SUSQUEHANNA STEAM ELECTRIC STATION
REVISION TO IE BULLETIN 83-03 RESPONSE
ER 100450/100508 FILE 842-03
PLA-2364

Docket Nos. 50-387
and 50-388

Reference: (1) PLA-1697 dated 6/9/83

FIGURE 9.2-5a

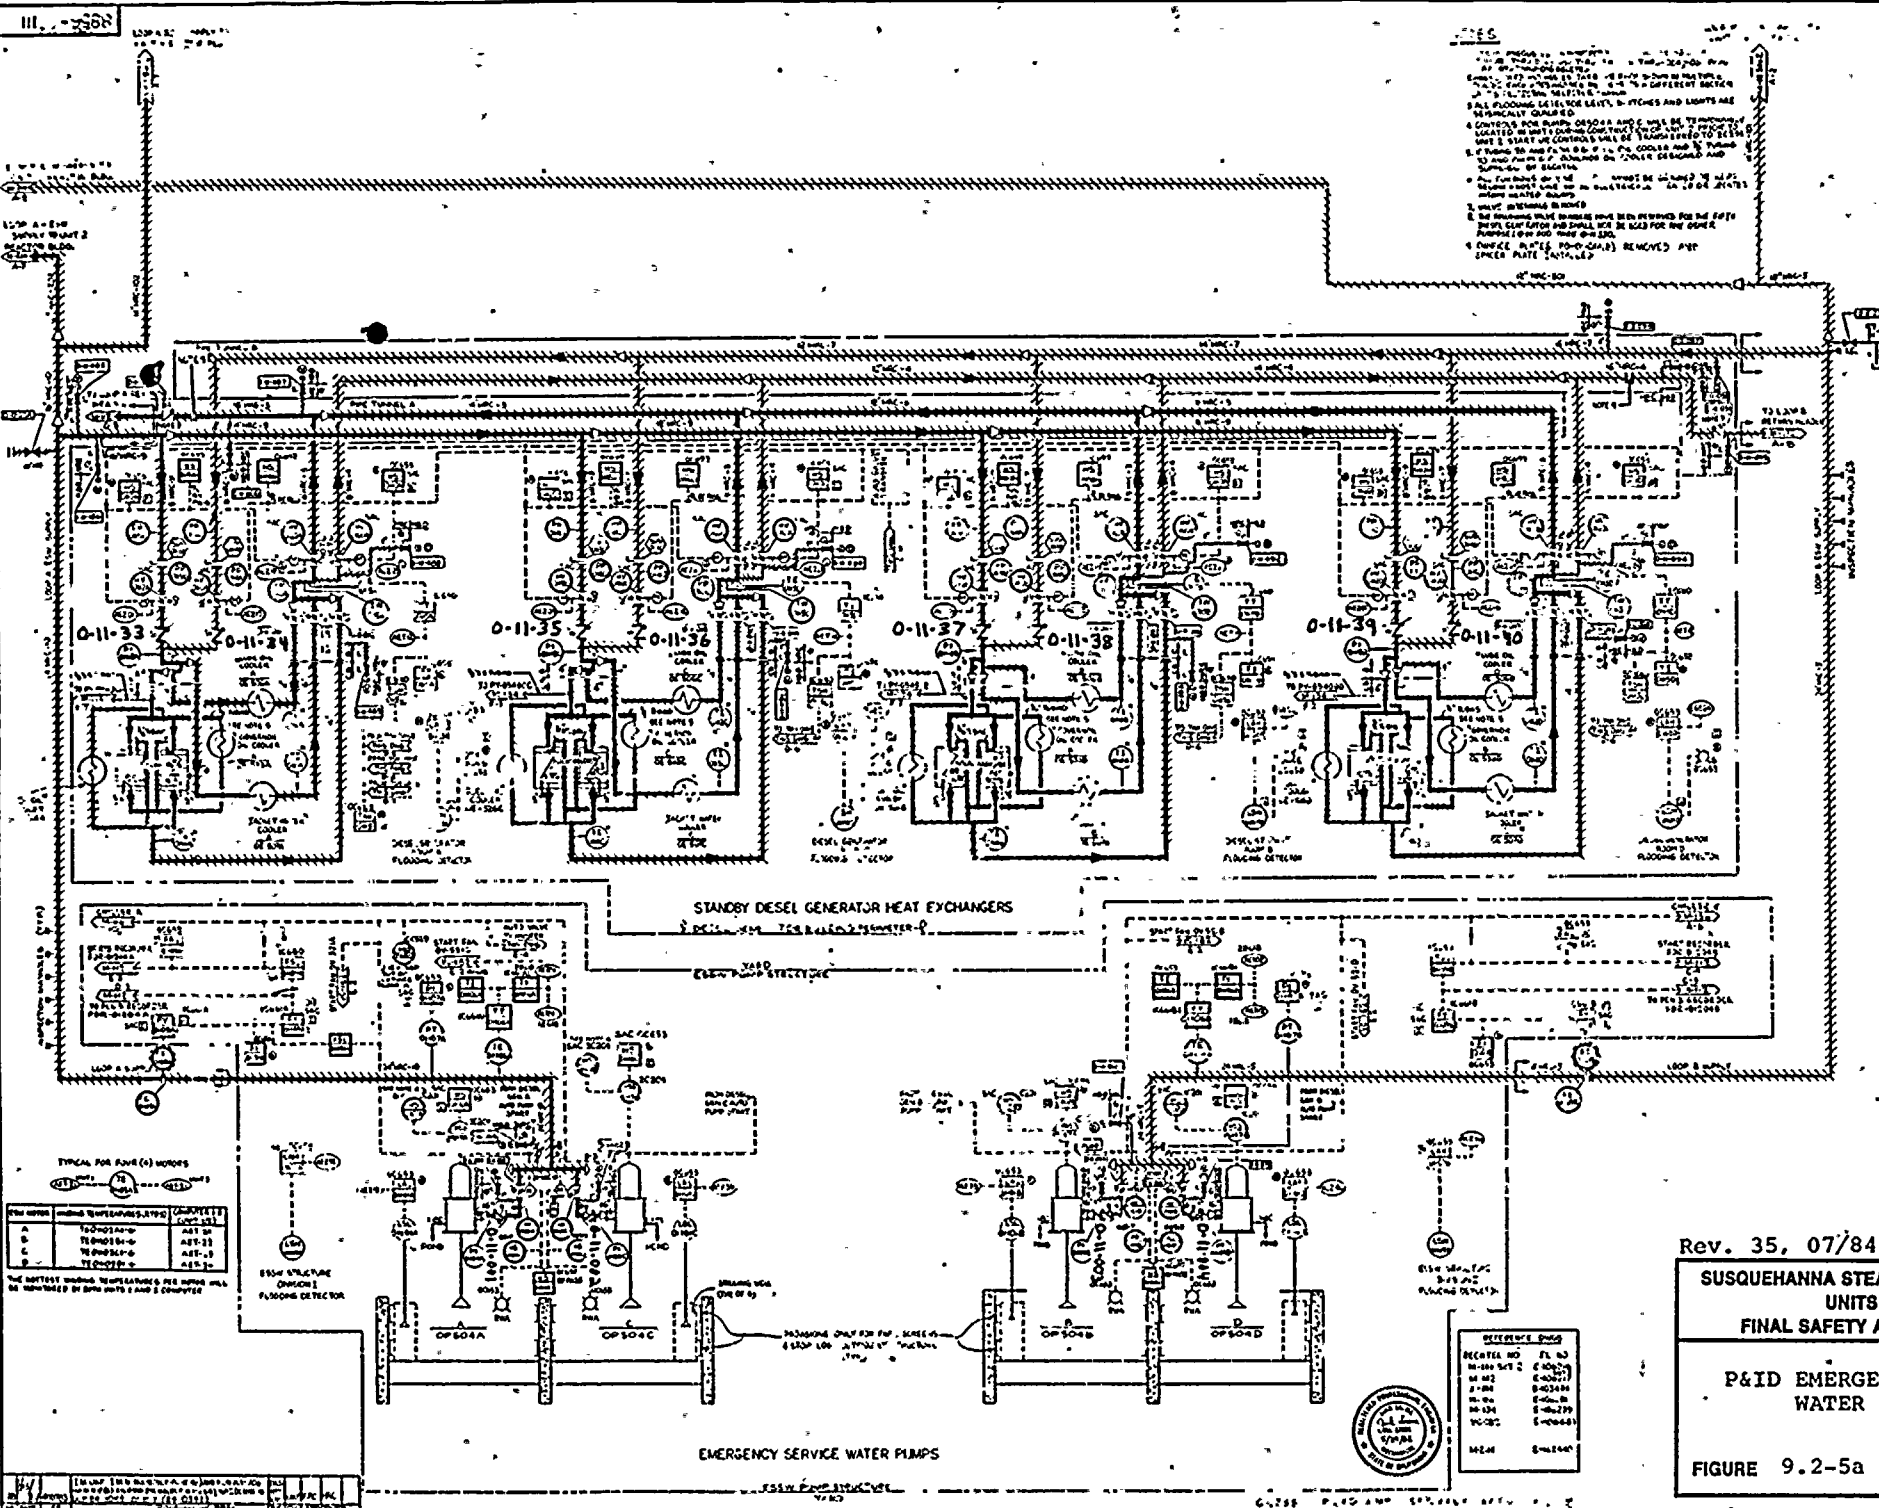
In order to disassemble and inspect all of the check valves as previously committed, it would be necessary to drain down the ESW Loops since the isolation function at each diesel is provided via butterfly valves which have leaked in the past. Recent leakage testing has shown that the isolation afforded via these butterfly valves will probably allow disassembly and inspection of the majority of the check valves. However, for 2 check valves (0-11-035 & 0-11-036 on the "C" Diesel), this disassembly may not be possible without draining both loops of ESW. Removing both loops of ESW from service necessitates a two-unit outage.

As an alternative to disassembly of all the check valves, we propose an inspection of as many of the check valves as is practical based on the ability of the butterfly valves to isolate the check valves for this inspection. The inspection then will include all the check valves at the pump discharges (0-11-001, 0-11-002, 0-11-003, & 0-11-004) and at least half the check valves located just prior to the diesel intercoolers (see attached figure). PP&L believes that this alternate inspection will provide adequate assurance of the integrity of the valves which are not inspected since the alternate inspection will encompass valves from the same manufacturer, in identical system locations, and under equivalent service conditions. In addition, a sampling of the valves as proposed is consistent with ASME Section XI inspection guidelines, offers a good representative sample, and affords us the necessary flexibility to work around the butterfly valve leakage problem. If any of the valves inspected show evidence of the problems noted in IE Bulletin 83-03, then PP&L will take the necessary actions to ensure the integrity of the remainder of the valves during the same outage.
